Meeting Summary

Technical Team #10

January 10, 2018 | CDOT Offices – Golden

A: EXISTING Pavement
(Operational Improvements)

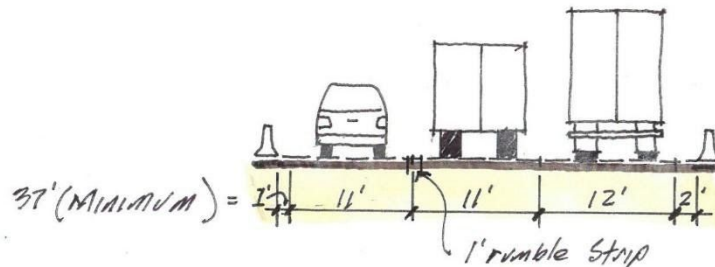
37' (minimum) – same as EB with 2 foot on right shoulder instead of 4. This could result in reduced speeds. Also reduces space for driver error. Some areas are wider (41' at some interchanges). Bridges are 38' wide. Shy on inside is 1' (same as EB).

TT Question: 37' is the narrowest portion in Focus Area 1. Are there other 37' sections in corridor? **A:** Yes. **Q:** If we start setting what we think is appropriate here, then would we be creating a precedent for other areas on the corridor? **A:** This section is unique because it is urban. Many of the decisions we are making here are sensitive to the urban context. Other sections of the corridor have different contexts (i.e. rockfall). So this will not necessarily be the template for the corridor. **Q:** So lane widths could change through the project area? **A:** We will go through each focus areas and then tie it all back together to smooth out lane widths.

Option B: Baseline 38'-40' – this is the section we developed and walked through on maps at two of the TT meetings.

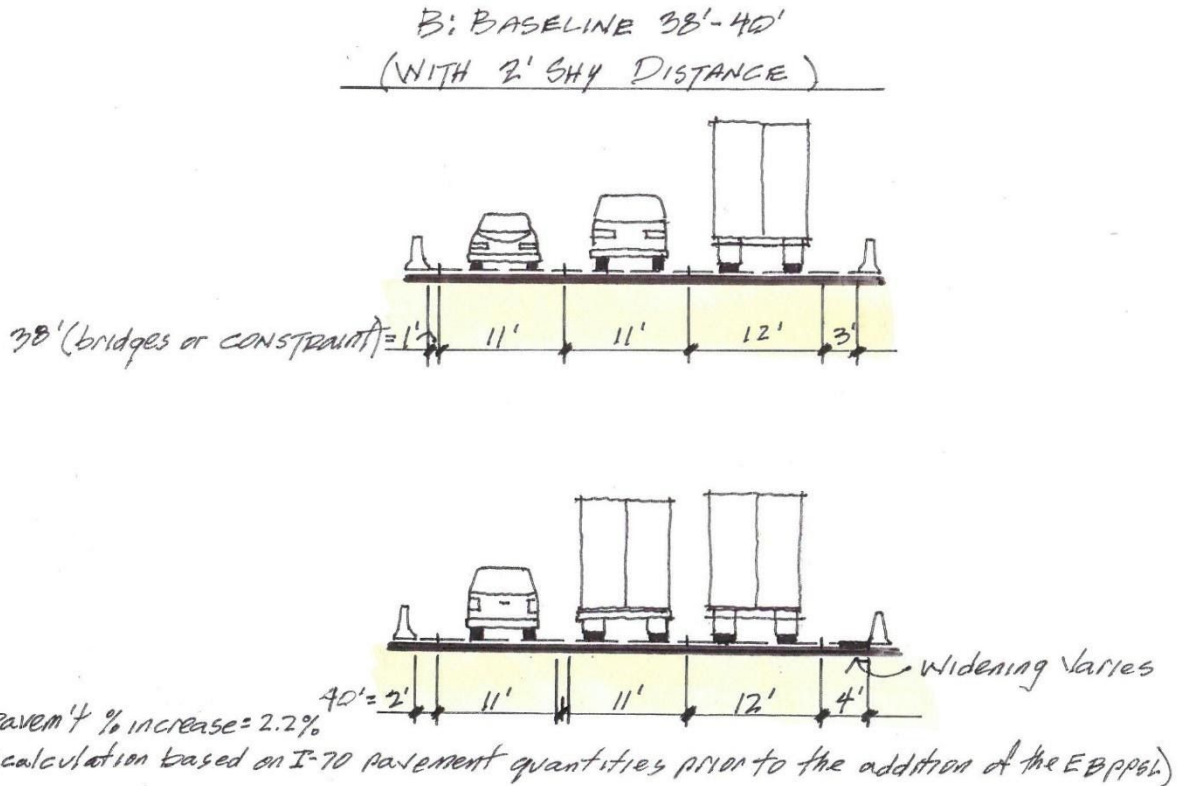
- Bridges will remain 38' wide as they are today.
- Off bridge – 4' on right hand shoulder and 2' shy on left

CCC Comment: The rumble strip is not a full foot, it is the width of the paint stripe. It is not taking 6 inches out of PPSL and adjacent GP lane. Putting a foot in for the rumble strip is superfluous because the strip is not 12 inches wide.

Tracy Sakaguchi (CMCA)– Would prefer to add a foot to rumble strip for trucks. Without this, there is no room for error. Truck drivers can't see the barrier, can't see the lanes, can't see anything beside them. The rumble strip is very important – it indicates that a driver might be floating on the wrong side of the line.

The only difference between EB and WB Baseline design is the 2' shy instead of 1' shy

Pavement increase is 2.2% with this option

TT question: Is the percent increase in pavement through the entire length of project or just Focus Area 1? **A:** Focus area 1 only and trimming at bridges.

TT question: Shy distance and median barrier – is a taller barrier more of a problem because it cuts off sight distance? Are we talking about adjusting shy distance in relation to height of barrier? **A:** This discussion is specific to Focus Area 1 with concrete barrier. Shy distance could vary based on what is currently striped.

CCC – change from 1' to 2' shy (in reference to jersey barrier and glare).

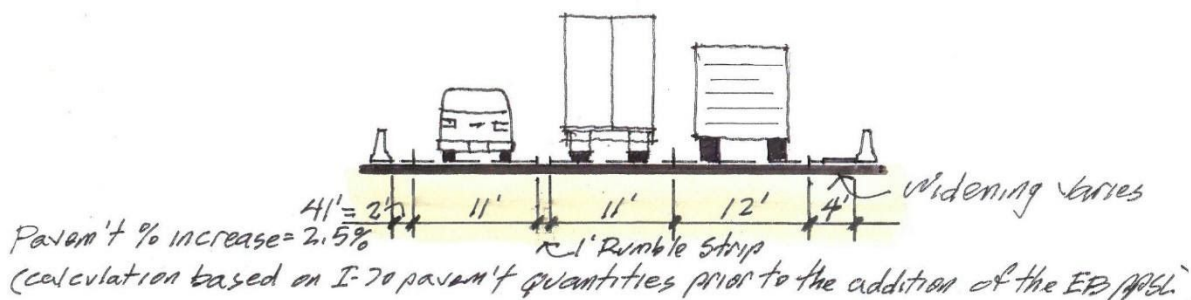
TT Question: Could we look at 2' shy on the bridges as well: 11' PPSL, 11' GPL, 12' GPL, 2' shoulder **A:** Yes, we could revisit this. We are showing wider shoulder on the right on bridges because the right side is open 24/7 and left side is open only during Peak Periods.

D: 38'-42'
 (WITH 2' SHY DISTANCE, 1' RUMBLE STRIP BUFFER & 12' CENTER LANE)

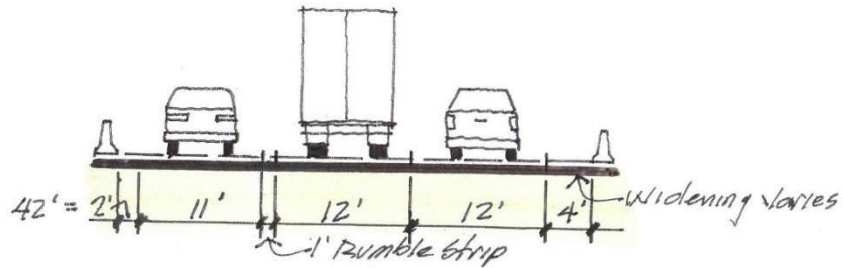
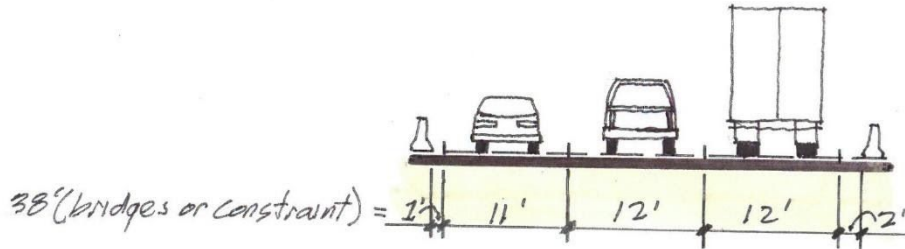
pavement % increase = 2.9%
 (calculation based on I-70 pavement quantities prior to the addition of EP PPSL)

CCC is concerned that if traffic and population grows, will there be pressure with 42 feet to just change the operation so that it becomes three lanes in use at all times? Then Clear Creek County never gets the high quality highway section we deserve. **FHWA:** For FHWA to sign off on this section being 3 general purpose lanes all the time, it would need to be a lot wider. There is no place for traffic to go if there is an incident. There is little room for driver error. **CCC:** This could become the maximum project if we start laying down a ton of pavement. Unpaved, hardened shoulders are part of this problem – could just pave them later – the footprint is set. CCC wants this to be an interim, 10-20 year solution.

E: 38'-43'
 (WITH 2' SHY DISTANCE, 1' RUMBLE STRIP
 BUFFER & THREE 12' LANES)

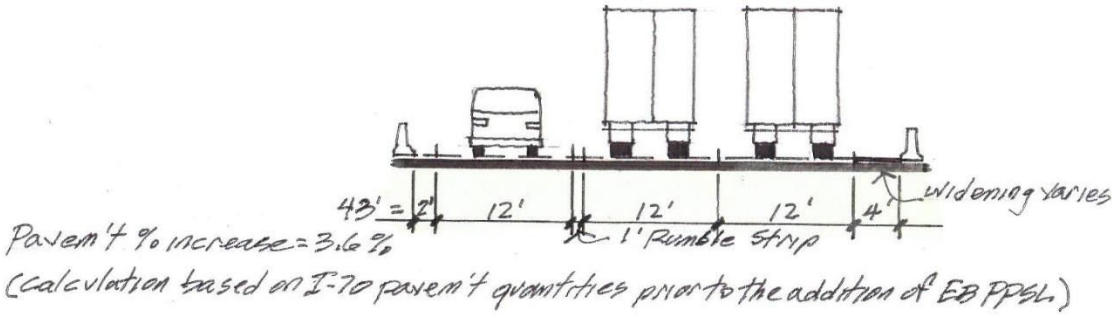
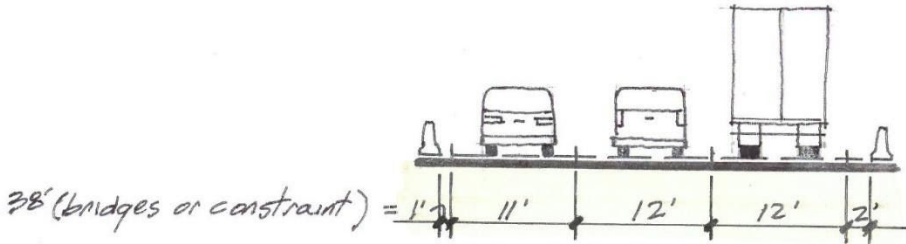
Option E: 43' – top range, all 12 foot lanes. Do not get as much safety value out of the additional foot as compared to previous options . Adds a foot to the shoulder lane.

The TT expressed concern that the highway could be changed, restriped, shoulders hardened, etc – slowly scabbing on a bigger footprint over time. The result would be a highway that was “good enough” and a maximum program will not happen.

CDOT responded: A change in operations like this would require a new CSS process and Tier 2 NEPA documentation for all operational changes (including striping, paving shoulders, etc). Nothing could be changed without going back through NEPA/CSS.
